**5-31 Nicholas Street
Site Plan Control Resubmission
Municipal File #: SP-07-24**

Nicholas Apartment Building
Picton
LANDSCAPE PLAN

LANDSCAPE PLAN

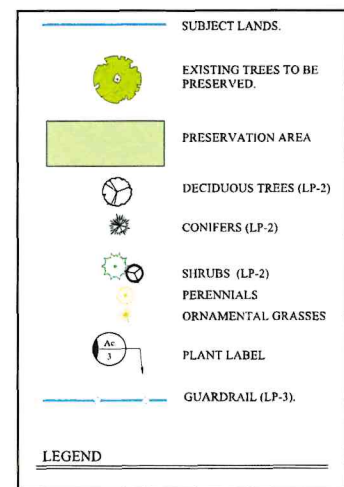
14	What is the purpose of the asphalt area located adjacent to the barrier free parking spaces?	The asphalt area located adjacent to the barrier free spaces beside the Apartment Building (Building E) is a Loading Bay.	Architectural Drawing Set, 100A.
15	Consider shared driveways for the townhouses and a shared walkway for the semis.	Thank you for your suggestion, the townhouse units continue to be serviced by separate driveways. The semi-detached building has incorporated a shared walkway to complement the site's grading and improve accessibility.	Architectural Drawing Set, 100A.
16	Incorporate a municipal cul de sac at the end of Nicholas Street.	These works are considered off-site and is not included as part of the current application. Coordination and implementation of this work can be addressed as a post-approval condition through the Site Plan Agreement.	N/A
17	Replace maple trees along Nicolas with smaller shrubs (concerns is long term interference with infrastructure due to root structure).	The maple trees along Nicholas Steet have been replaced.	Landscape Drawing Set, LP-1.

18	Add additional trees along property boundaries.	Additional trees are not proposed due to stormwater management constraints along the property line adjacent to the cemetery. As a result, further planting in this area is not feasible and is not included in this application.	N/A
19	The pathway to Delhi Park will require a corner mirror and lighting.	These works are considered off-site and is not included as part of the current application. Coordination and implementation of this work can be addressed as a post-approval condition through the Site Plan Agreement.	N/A
20	Delineate property boundaries on all plans.	Property boundaries reflecting the post conveyance site boundary have been delineated on all respective plans within this submission. For the purposes of zoning compliance, the pre-conveyance site boundary shall apply.	Civil Drawing Set, 101. Landscape Drawing Set, LP-1. Architectural Civil Drawing Set, 100A.
